ONE COURSE CEMENT CONCRETE SIDEWALK, ITEM 560  
(WITH GRANITE CURB)

# REVISIONS AND CORRECTIONS

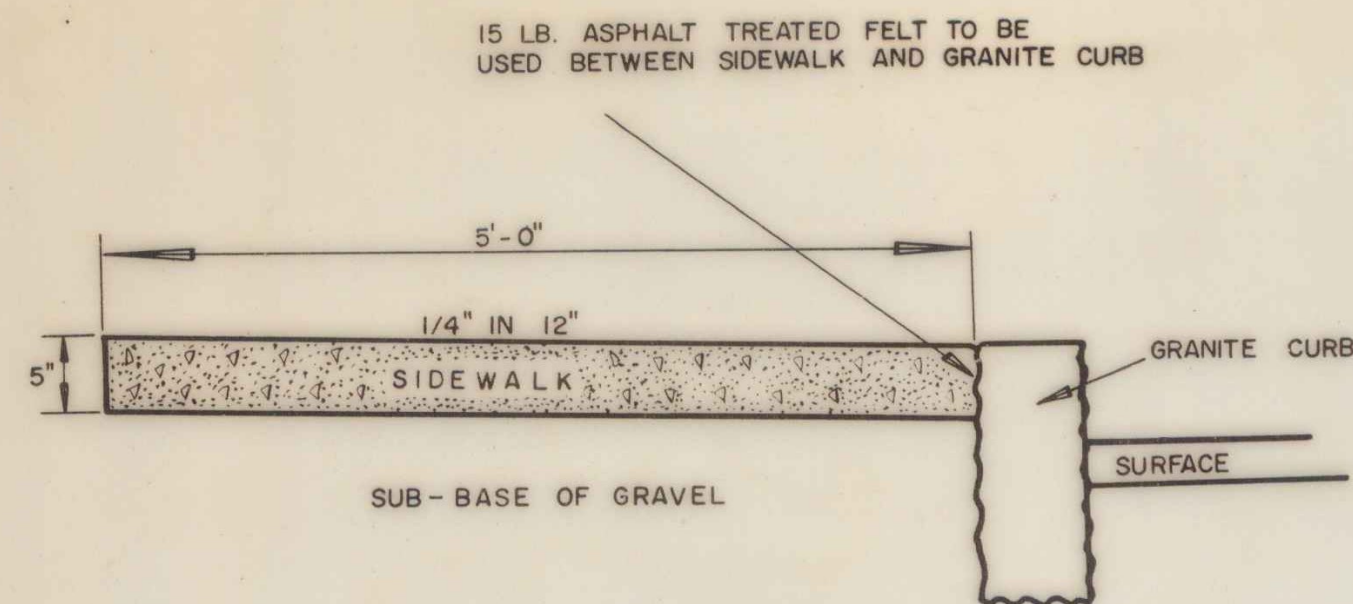
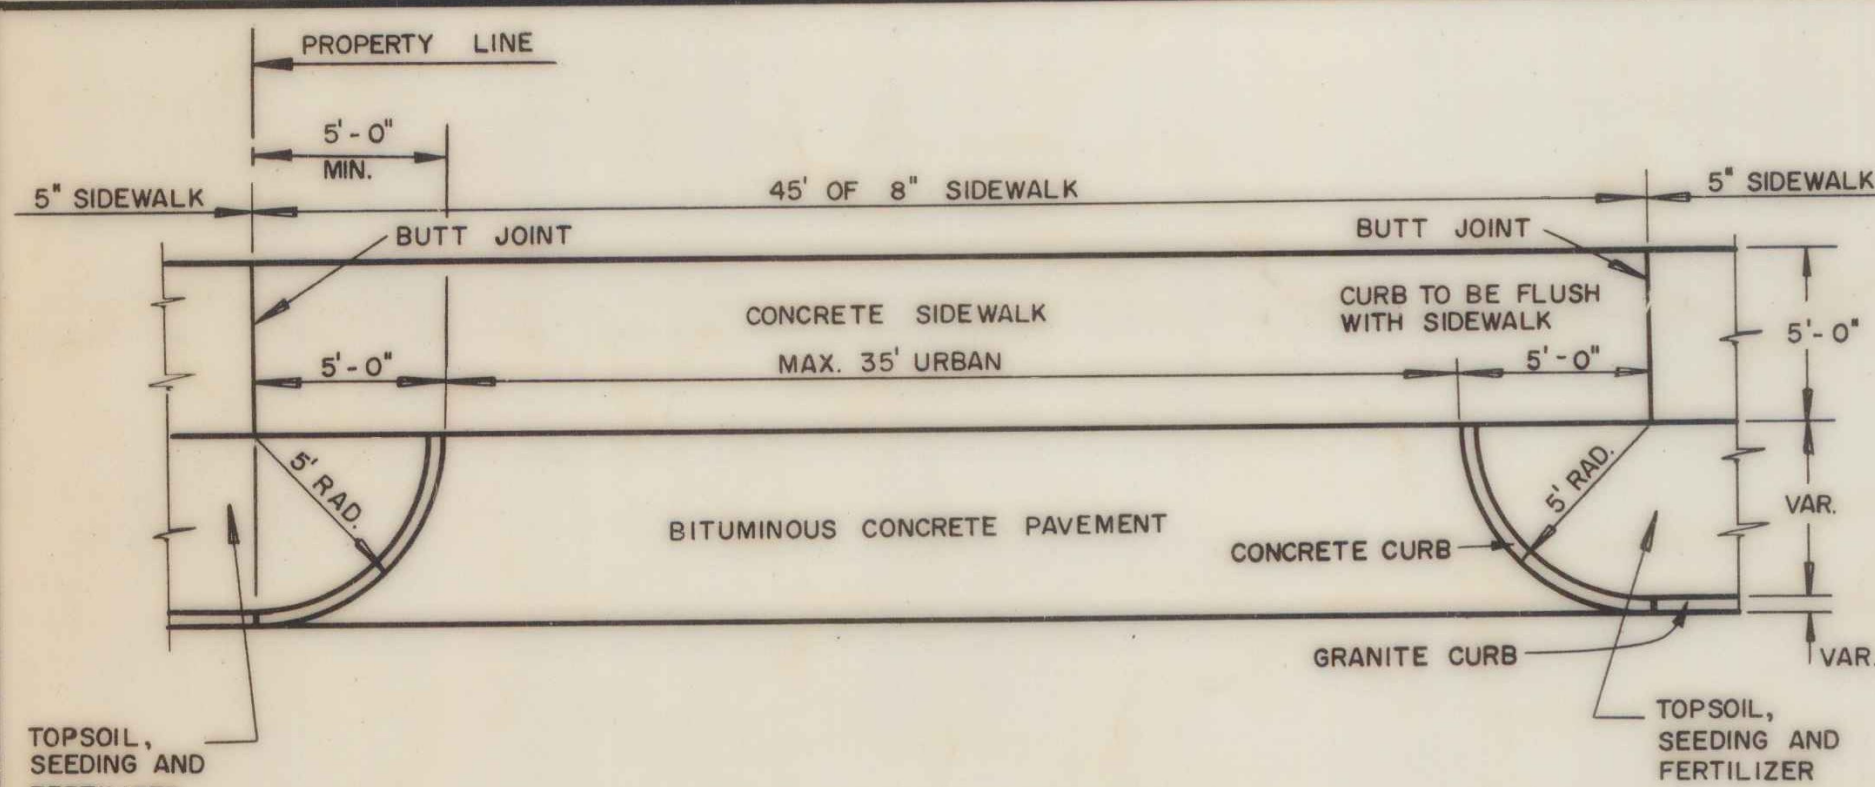
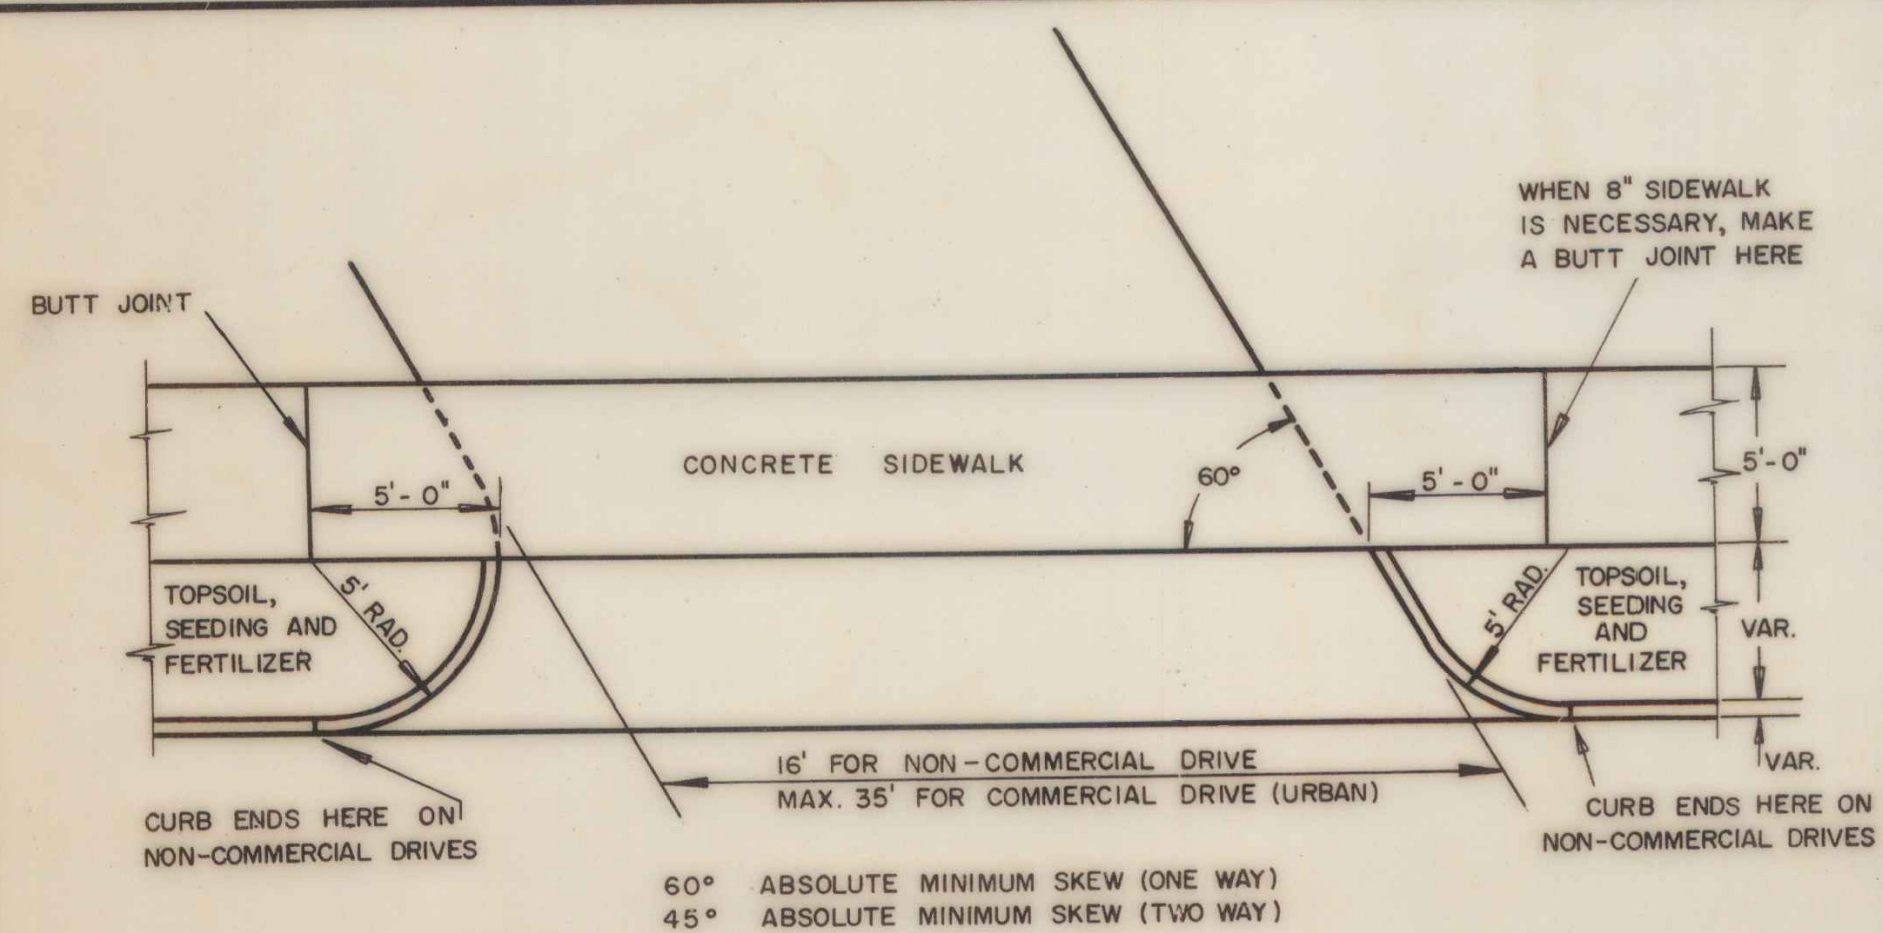
THIS SHEET AND C-2, SUPERCEDE SHEET C-2 APPROVED MAY 26, 1958  
DETAILS OF GRANITE CURB ENDS CHANGED JUNE 16, 1959  
DIMENSIONS FOR COMMERCIAL DRIVES CHANGED FROM 30' TO 35' URBAN  
SEPT. 29, 1959.  
DIMENSION FOR ASKEW DRIVE MADE PARALLEL TO ROAD CENTERLINE AND  
DISTANCE TO PROPERTY LINE AND BETWEEN DRIVES, NOTED OCT. 13, 1959  
SIDEWALK AND RAMP VARIATION NOTE, OCT. 29, 1959  
GRADIENT BEHIND SIDEWALK CHANGED FROM 0.0 TO -6.0 JUNE 9, 1960  
CONCRETE RADIUS CURB PAYMENT NOTE ADDED APRIL 9, 1962  
MAR. 1, 1965. HEIGHT OF STRAIGHT CURBING ENDS, AT DRIVES, REDUCED  
FROM 1 1/2" TO 1". RAMP SLOPES CHANGED FROM 3/4" IN 12"  
TO VARIABLE
